From: David E. Broxton [broxton@lanl.gov]
Sent: Monday, December 06, 2004 10:58 AM
To: john_young@nmenv.state.nm.us
Cc: Thomas J. Whitacre; mjohansen@doeal.gov; katzman@lanl.gov; vaniman@lanl.gov; Mark Everett; John McCann; spearson@lanl.gov; mdale@lanl.gov
Subject: R-18 Well Design

R-18 Well Design

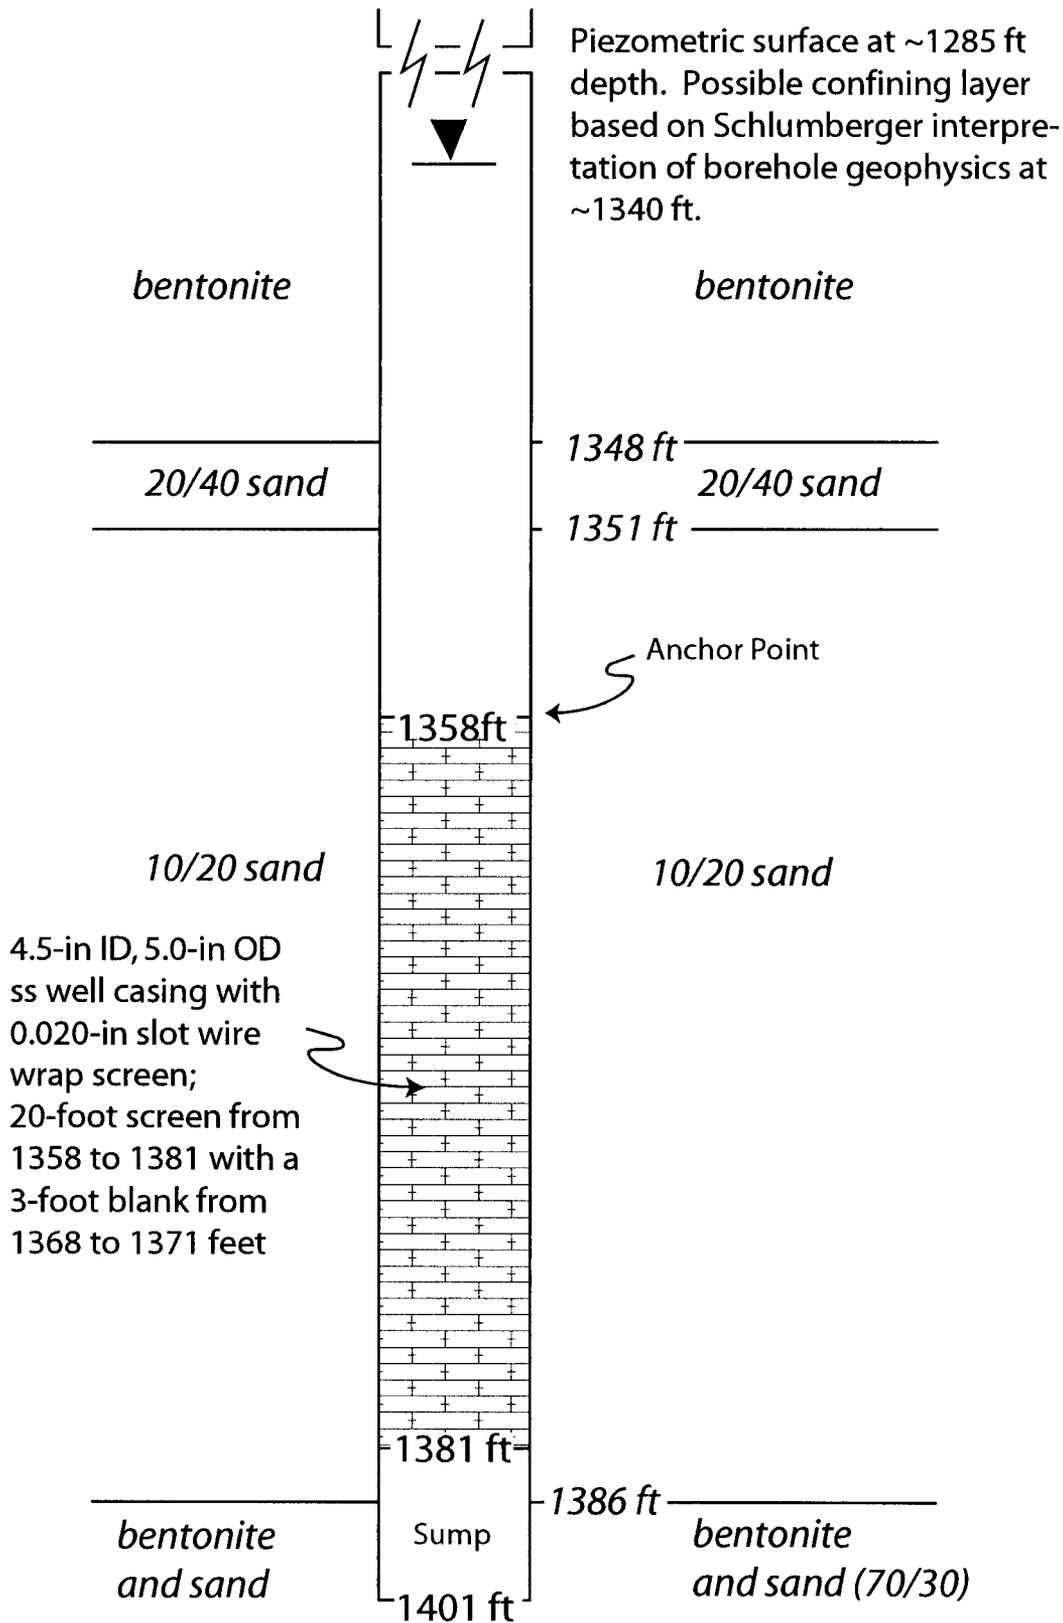
Based on Schlumberger's interpretation of the logs, fully saturated conditions for the regional zone of saturation begin at a depth of 1340 ft at R-18. This interpretation is based on the divergence of porosity measurements calculated from the density log (total porosity) and the neutron porosity log (water-filled porosity) above 1340 ft and their convergence below. Resistivity logs and the formation microimager (FMI) suggest a possible clay-rich confining layer was penetrated from approximately 1337 to 1340 ft depth. Tighter conditions apparently extend to 1348 ft depth. Confined conditions are consistent with a piezometric surface measured between 1285 and 1288 ft depth and lack of full saturation above 1340 ft.

Schlumberger identified the zone between 1350 and 1370 ft as a favorable screen location because of higher porosities and larger pore spaces based on the CMR log. Schlumberger noted that porosity generally increases with depth to the bottom of the borehole. Based on the borehole geophysical information, we modified the well design so that the screen interval extends from 1358 to 1381 ft and the sand pack from 1348 to 1386 ft.
